SERVICE No. 1103B BULLETIN

Date: November 25, 2003 (S)

Service Bulletin 1103B adds the requirement of inspecting the nose gear actuator mounting bolt to ensure sufficient thread engagement with the lock nut after the engine mount has been replaced. This inspection and bolt replacement is only required if the engine mount was found cracked and is being replaced or has been replaced with the engine mounts listed in Table 1 for your aircraft.

ENGINE MOUNT INSPECTION

(PA-46-310/350P)
Typical Engine Mount
(Arrows indicate Engine Mount Actuator Attach Feet)
Figure 1A

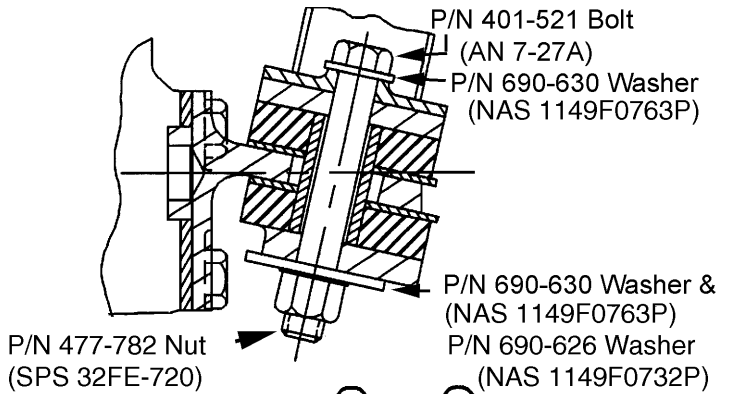
It has been determined that cracks may develop on the engine mount in the area of the nose gear actuator attach feet (see Figure 1A). This condition typically occurs when the nose landing gear is subjected to excessive loads, possibly through hard landings, rough field operations, excessive speed turns and/or improper towing of the aircraft.

1. Clean the engine mount actuator attach feet area.
2. Remove the paint or Dinitrol AV8, if the paint was previously removed and covered with Dinitrol AV8, from the feet (ref. Figure 1A).

3. Visually inspect the engine mount actuator attach feet for cracks.
4. Perform a 'liquid penetrant inspection' of the engine mount actuator attach feet for cracks per AC 43.13-1B, Chapter 5, Section 5.

Figure 2
Old Engine Mount
Weld Indicates Two (2) Piece Foot

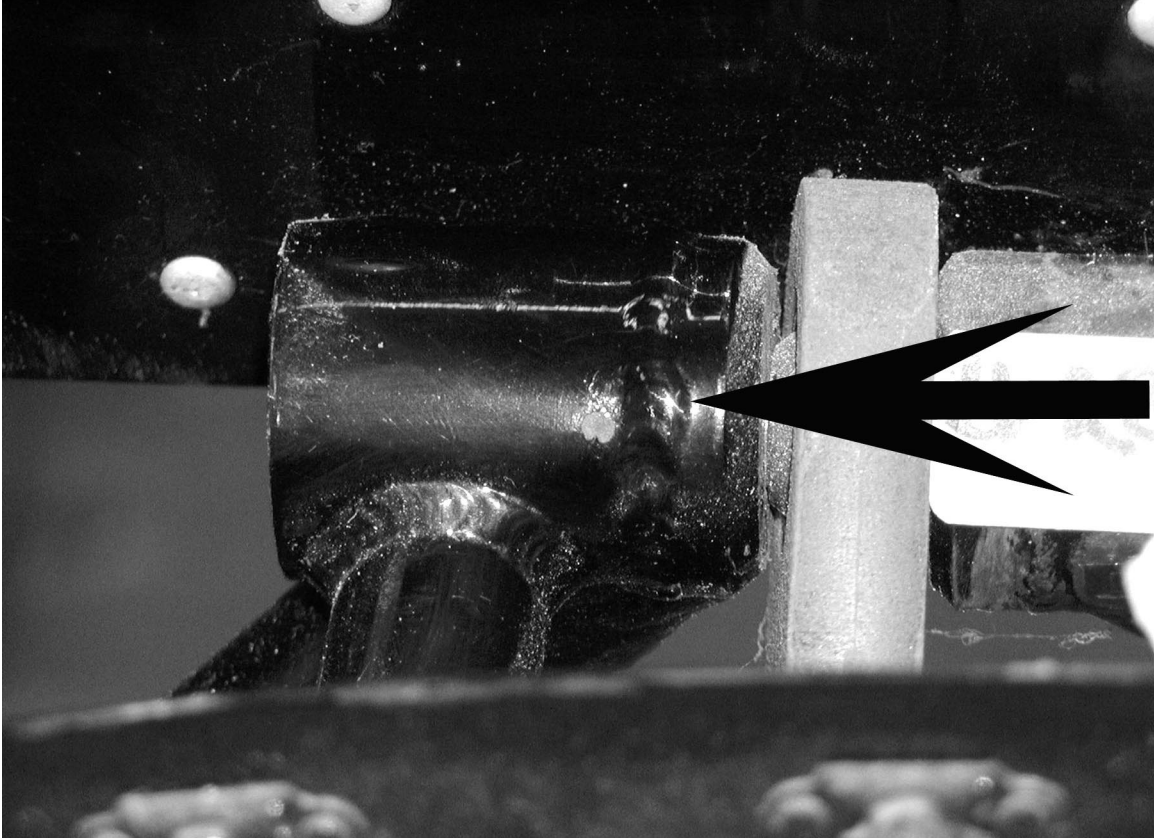
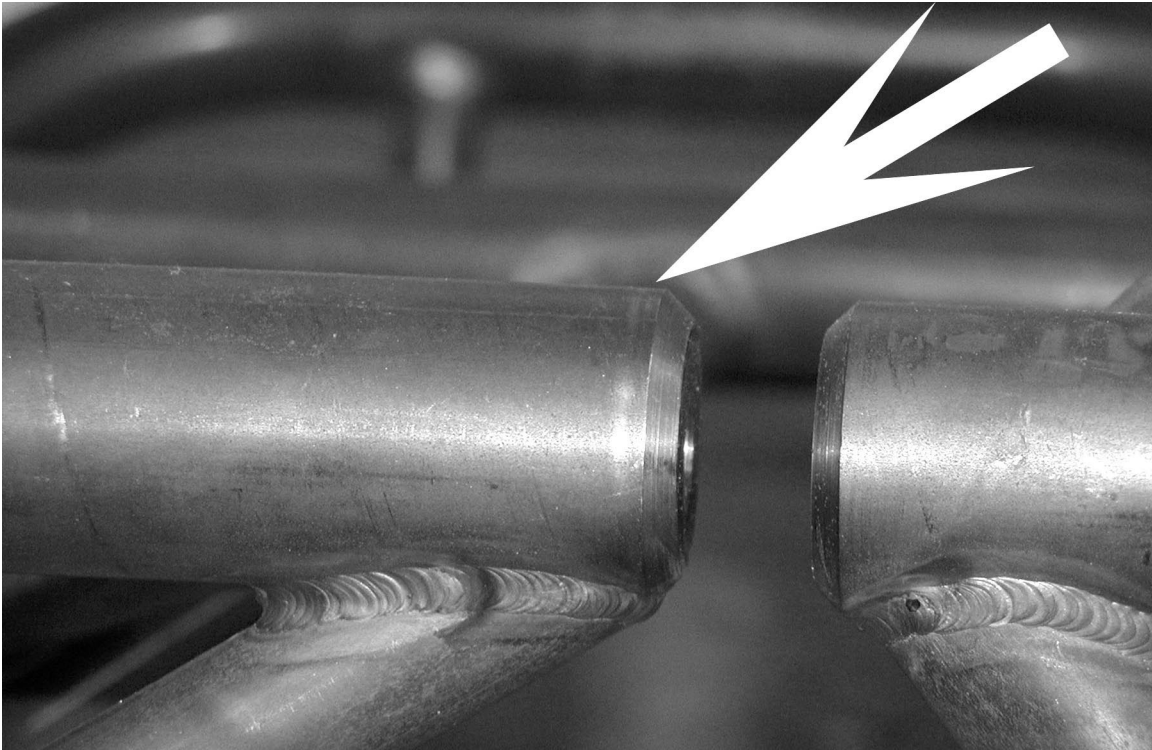
1. If cracks are found on the engine mount, replace with the engine mount listed in Table 1 for the applicable aircraft type. Insure the new engine mount has the one (1) piece feet (see Figure 3). The old engine mount (see Figure 2) has a two (2) piece welded foot. This welded area is where the crack's in the engine mounts have been found. Replace engine mount per the Aircraft Maintenance Manual, Chapter 71-00-00.

5. If a crack appears in either of the actuator attach feet, the engine mount must be replaced before further flight. The installation of the appropriate engine mounts (see Table 1 on Page 2), with the one (1) piece feet (see Figure 3) constitute compliance with PART I and PART II of this Service Bulletin.
